Category S	Repair Guidance	Ref. No. R001/14 B	Page 1 of 4
Coverage <input type="checkbox"/> Distributor only <input checked="" type="checkbox"/> Please inform your dealers		Date Issued January 6, 2014	
Please convey this information to your <input type="checkbox"/> Director <input checked="" type="checkbox"/> General Manager <input checked="" type="checkbox"/> Warranty Dept. <input checked="" type="checkbox"/> Parts Dept. <input checked="" type="checkbox"/> Training Dept. <input checked="" type="checkbox"/> Field Rep.		Date Revised July 29, 2014	
Applicable Model Mazda3(BM)		Applicable Countries or Specifications Worldwide

Revised

Subject: Rattle noise from bottom of A-pillar

[Illustration of creating a clearance]

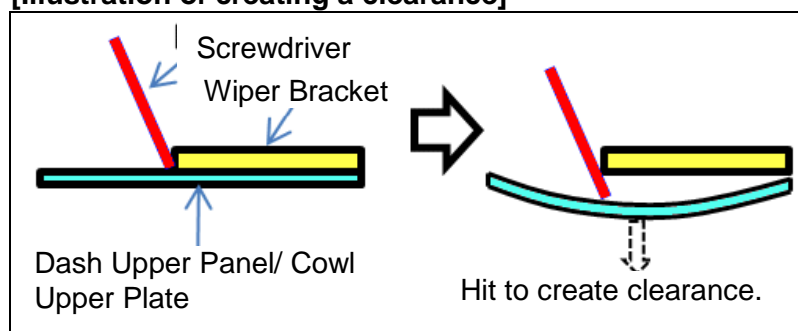
1. Remove **the bonnet and** the cowl grille according to workshop manual.
2. Place the tip of a covered ^(*) flat-blade screwdriver between two panels at joint. (Wiper Bracket~Cowl Upper Plate and Wiper Bracket~Dash Upper Panel) Then hit the head of the screwdriver by hammer to create a clearance of approx. 0.5mm between the two panels.

^(*) **Note:** To avoid damaging the paint, wrap protection tape around the tip of the screwdriver. If there are scratches on the panels, apply appropriate corrosion protection primer.

[Locations to create a clearance]

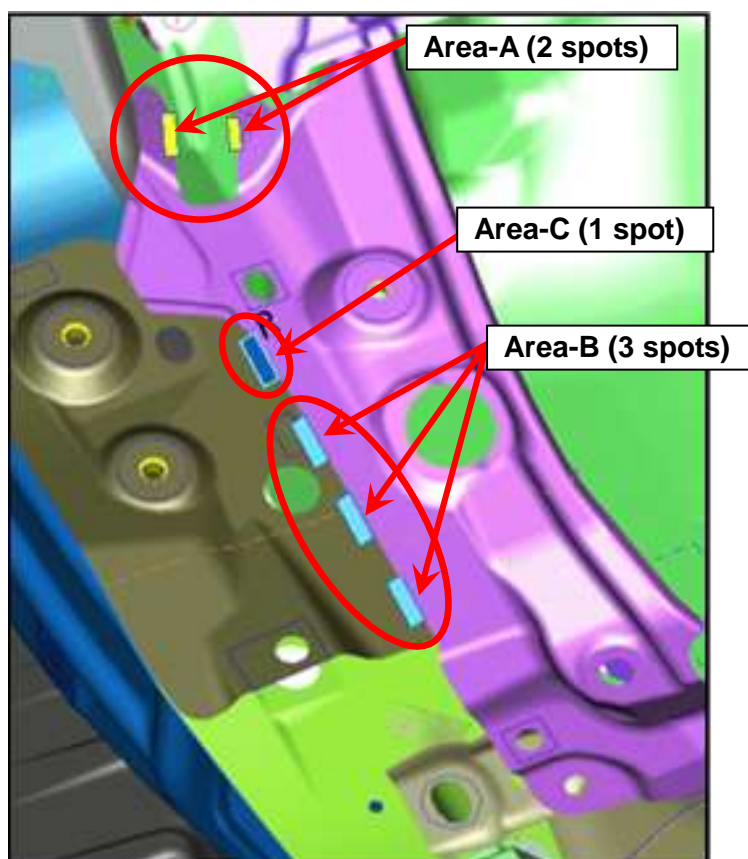
- Area-A and B: Create a clearance for all vehicles
- Area-C: Create a clearance for vehicles with the indicated limited VIN ranges.

Area-A for all vehicles.

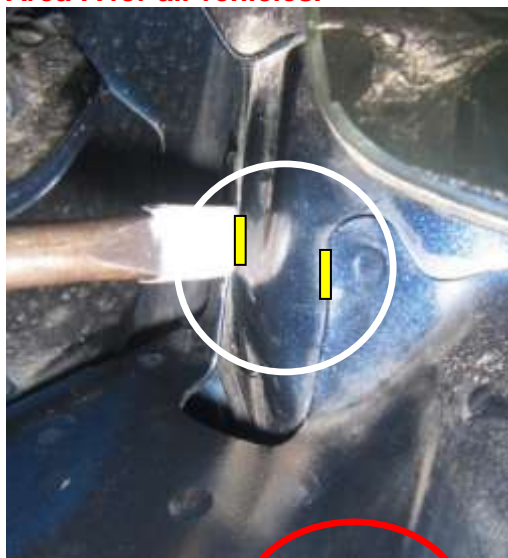
3. Apply a body adhesive to the Area-A between the wiper bracket and the dash upper panel (two locations shown in the figure).

Area-C for vehicles with the following VIN ranges

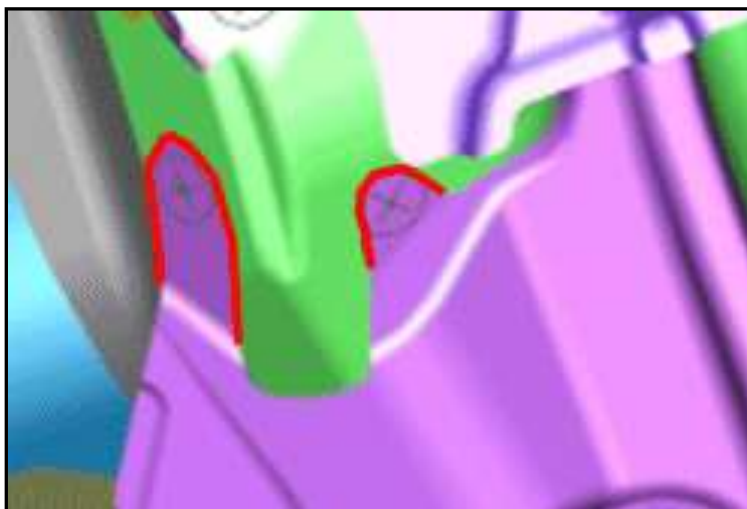
US Spec.	From JM1BM**** ** 100001 - 189735
EC Spec.	From JMZBM**** ** 100001 - 140922
Israel Spec.	From JMZBM**** ** 100001 - 116455
ADR Spec.	From JM0BM**** ** 100001 - 116455
General Spec.	From JM6BM**** ** 100001 - 116455
	From JM7BM**** ** 100001 - 116455
